Submissions and Amendment Report

Western Sydney University Indigenous Centre of Excellence

Western Sydney University
Parramatta South Campus
171 Victoria Road, Parramatta

SSD-64916225

Figure 2 Proposed eastern and western P1 car parks

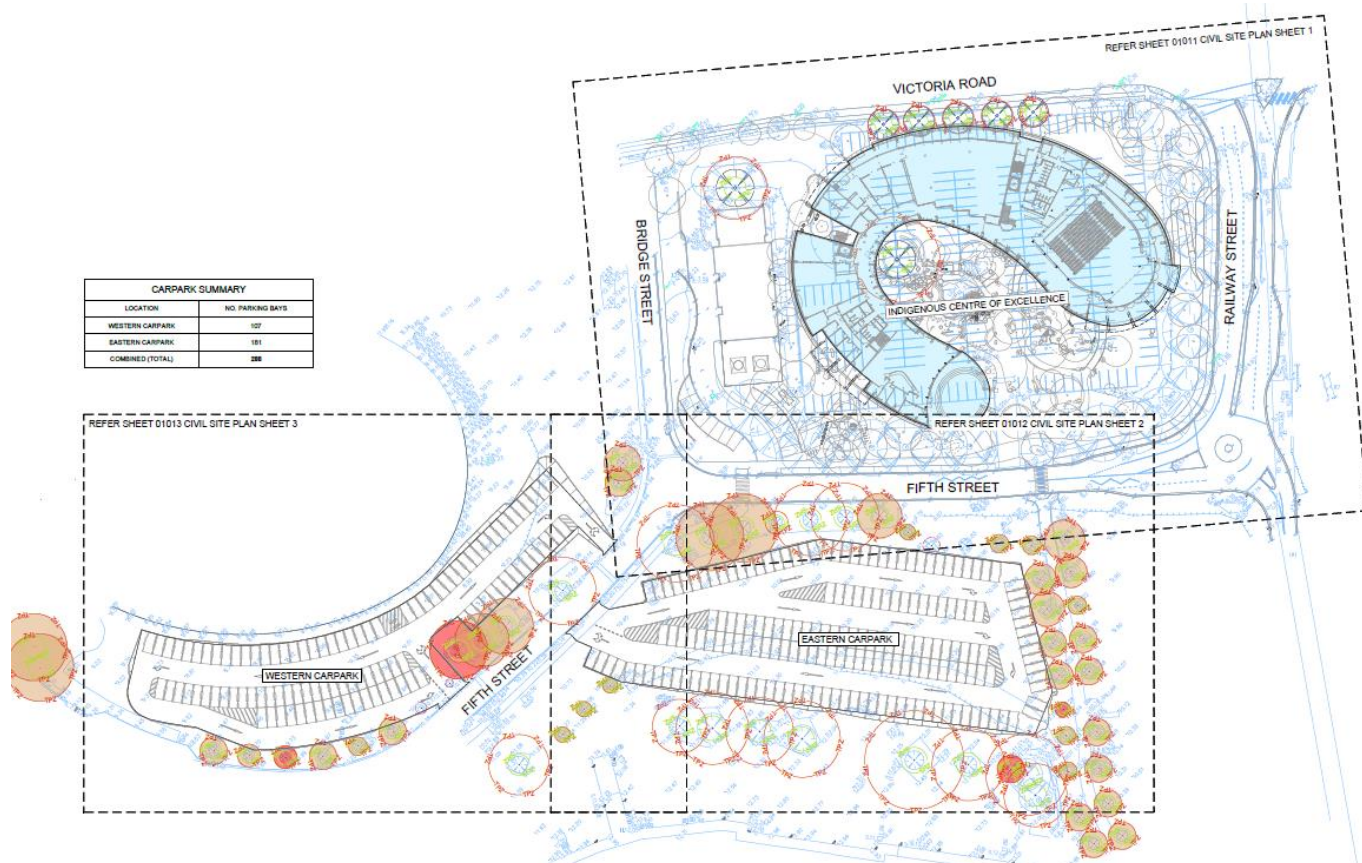
Full details of the proposed car park works are set out in the documentation prepared by TTW including Civil Drawings (**Attachment K**). **Figure 2** below illustrates the new car parks.

Figure 3 Trees to be retained and removed

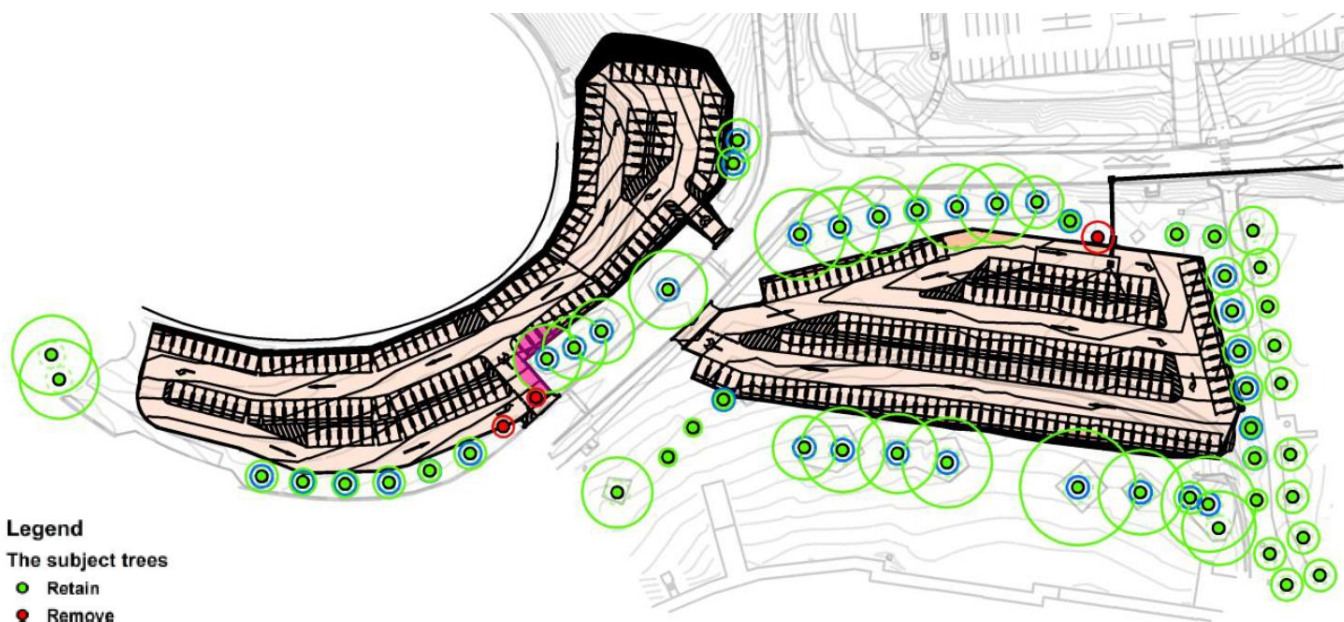
A total of three (3) trees are required to be removed to accommodate the new car parking areas. Of the total three (3) trees identified for removal, two (2) are located along the south-eastern boundary of the western car park, and one (1) is located at the northern boundary of the eastern car park. Refer to **Figure 3** on the following page.

Figure 4 Proposed extent of car park re-grading

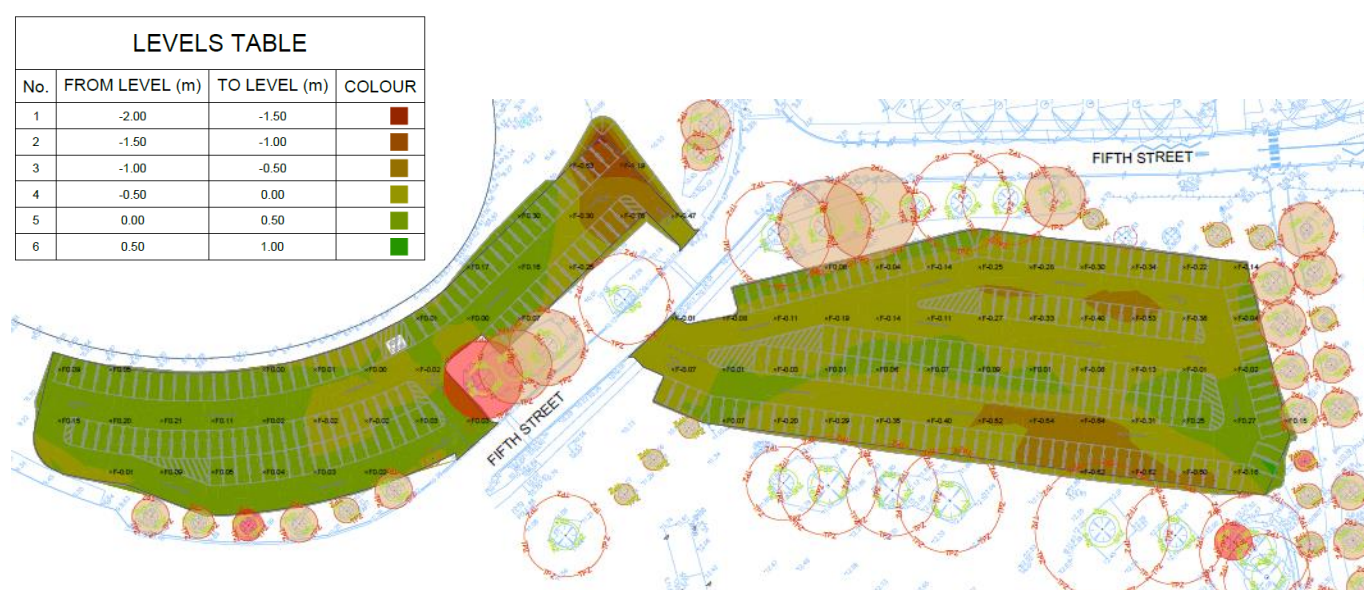
The extent of cut and fill works is indicated in **Table 6** and also within **Figure 4** below.

Figure 5 Proposed typical section of remediation 'burrow pit' design

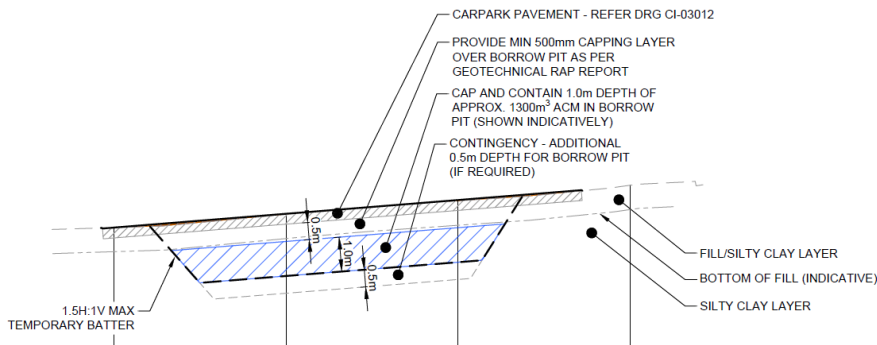
On this basis, two remediation pits have been proposed beneath both eastern and western car park, which includes excavation or 'over cut' of between -0.5m to -2.0m to enable up to 1.5m depth of potential ACM (with 0.5m of that as a contingency) and a suitable 0.5m top capping layer beneath the car park asphalt paving and turfcell system. Refer to the indicative section extract provided at **Figure 5**.

Figure 6 Stormwater and Drainage Detail – Western Car park

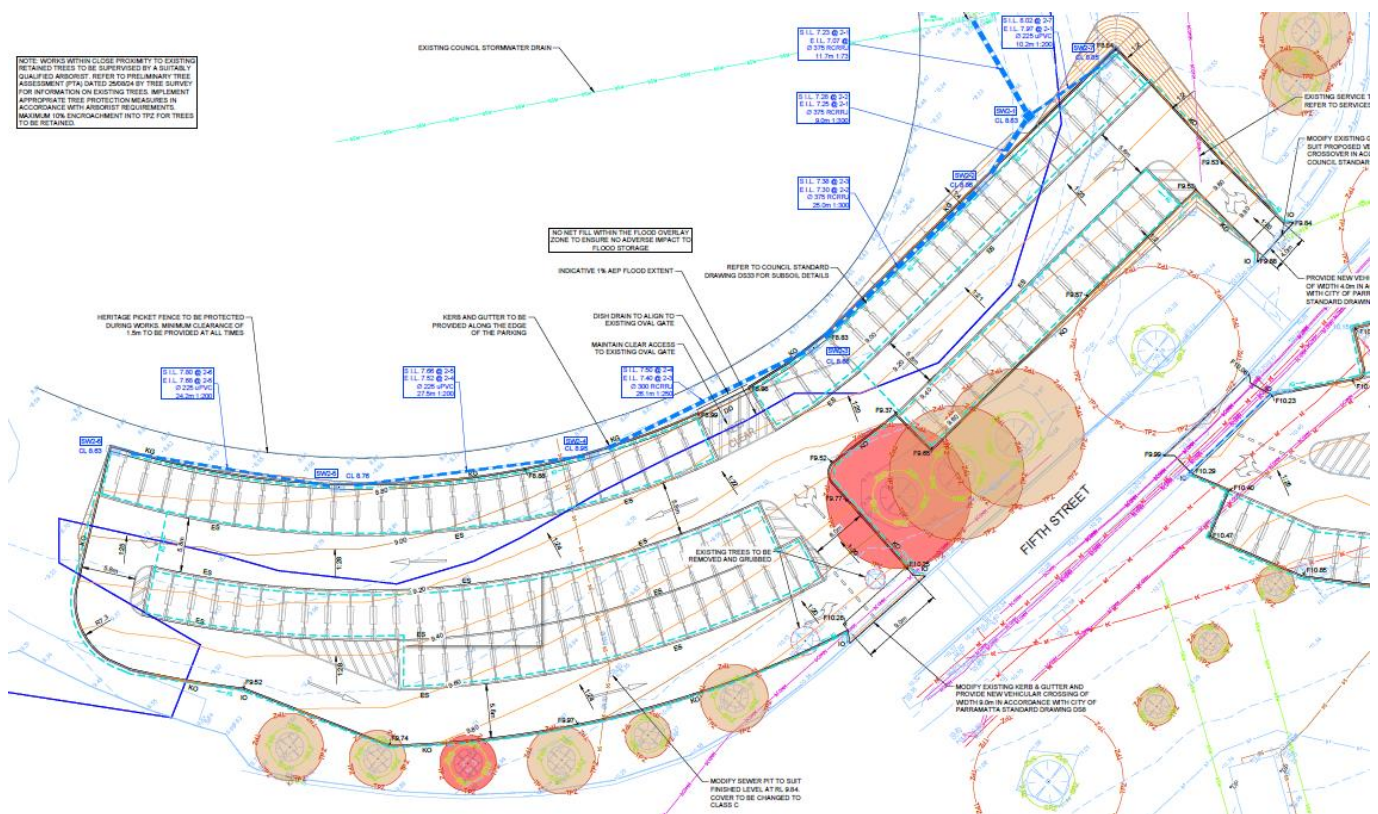
At the western car park, no below ground detention tank is proposed. As the western car park will accommodate a topography with a natural slope towards the oval, six (6) new stormwater pits are proposed to accommodate stormwater drainage run off. Refer to **Figure 6** below.

Figure 7 Stormwater and Drainage Detail – Eastern Car park

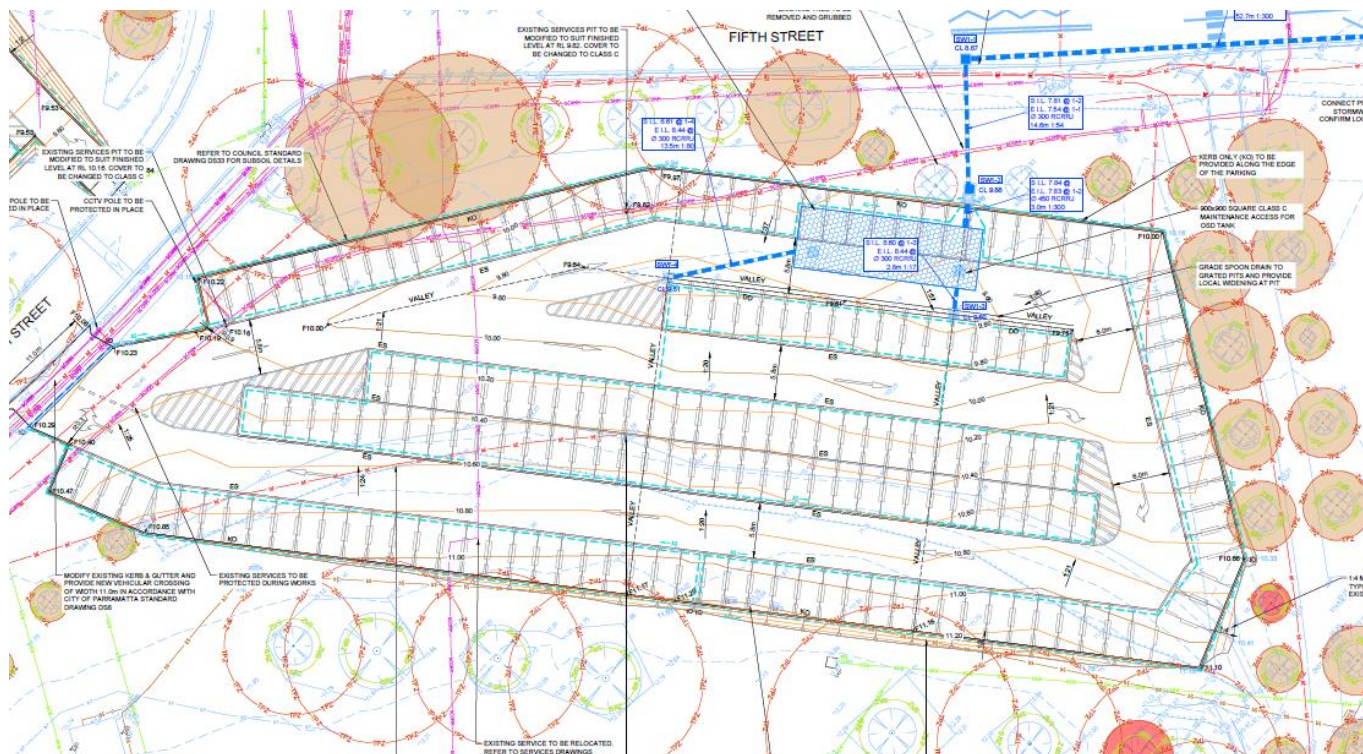
At the eastern car park, an indicative 110kL below ground tank combined with above ground detention system is proposed. Two new stormwater pits are proposed to be constructed within the car park area which will discharge into the new tank. New stormwater piping will be installed from the proposed tank and along Fifth Street where it will connect into existing pits further east. Refer to **Figure 7** below.
